AIREX BUILDING ADDITION

STAFF REPORT #2

July 13, 2022

**RE: RESPONSE TO TOWN DEPARTMENT & PEER REVIEW COMMENTS
PROPOSED INDUSTRIAL BUILDING ADDITION
17 & 19 EXECUTIVE DRIVE (TAX MAP 209, LOT 8 & TAX MAP 215, LOT 8)
HUDSON, NEW HAMPSHIRE**

FIELD BOOK: 1264	DRAWING NAME: 5843SITE-EC21	5843 SITE	3 OF 14
DRAWING LOC: J:\5000\5843\DWG\5843 SITE		File Number	Sheet

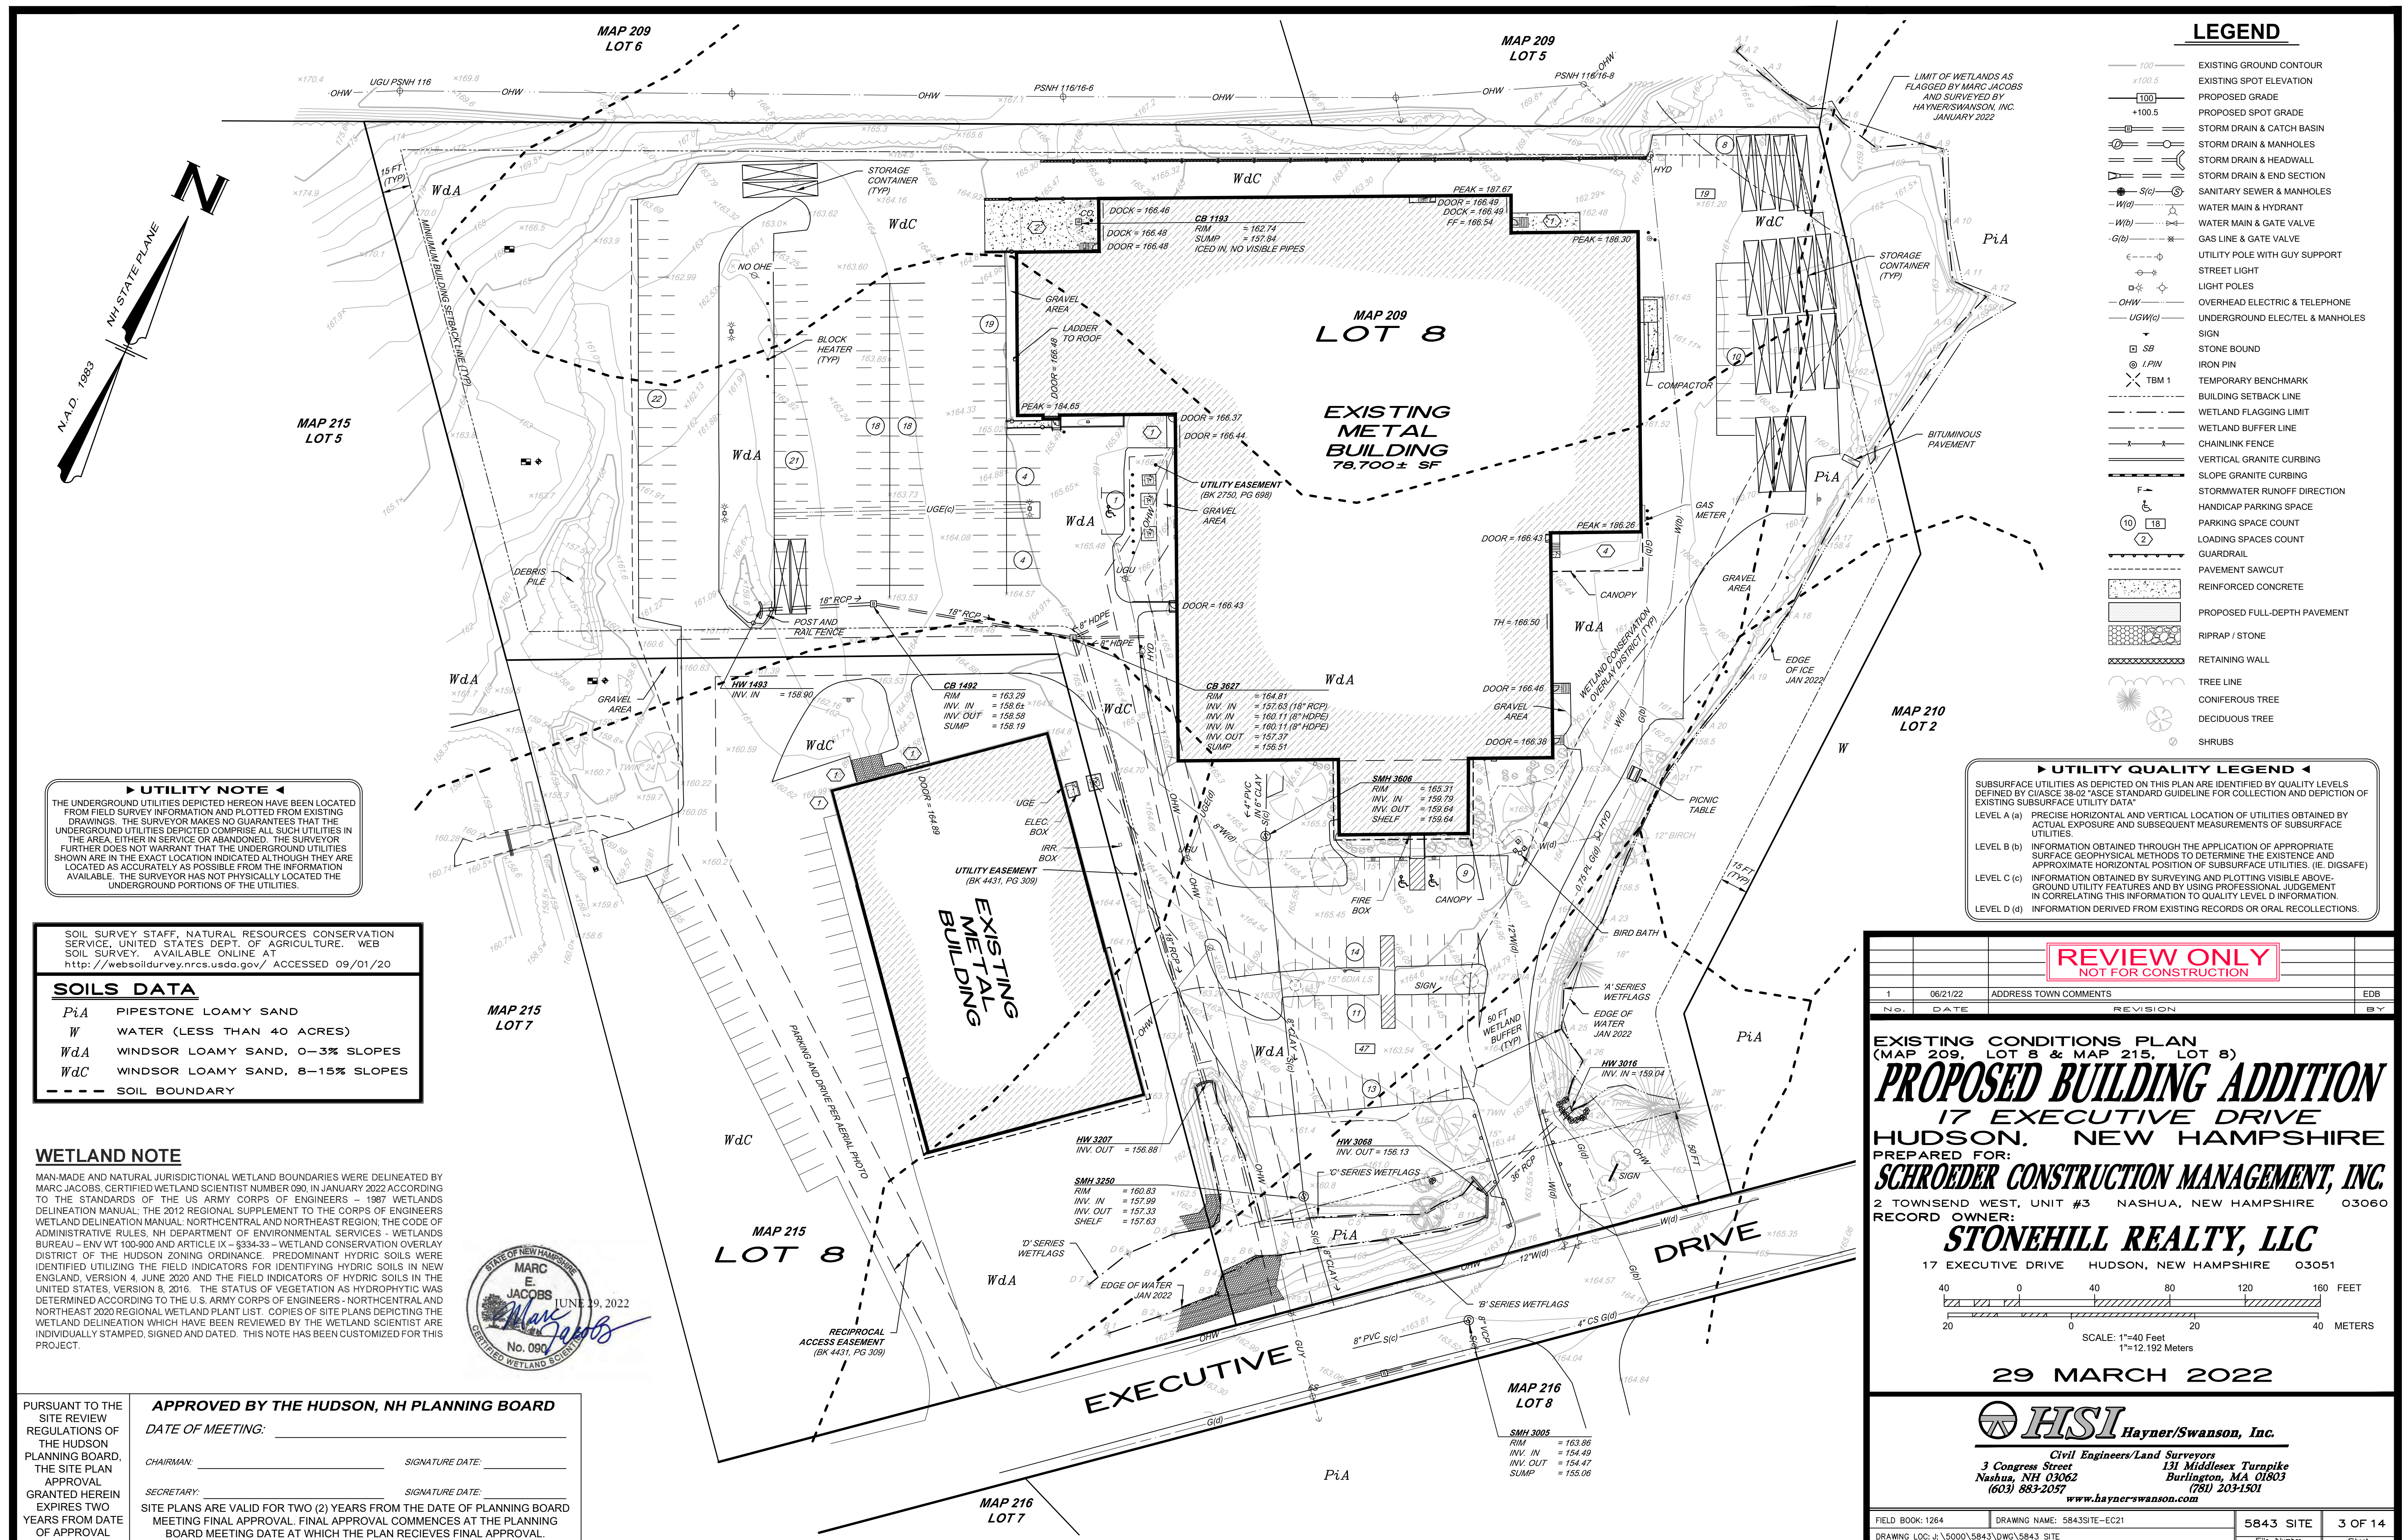
- b. HR 275-6.I. The scope of this review does not include the adequacy of any fire protection provisions for the proposed building addition. The applicant has not shown the existing water connection to the site on the plan set.

- b. We note that there appears to be an existing stop sign and stop bar at the driveway that is not shown on the plan set.

Sprinkler system calculation will be provided to the Building and Fire Departments for the required Building permit. The existing water main information is shown on Sheet 3 of 14 of the Site Plan, which has been revised from 20-scale to 40-scale to show the entire site.

The existing stop sign and stop bar at the Executive Drive site driveway shown on the revised Sheet 3 of 14 of the Site Plan.
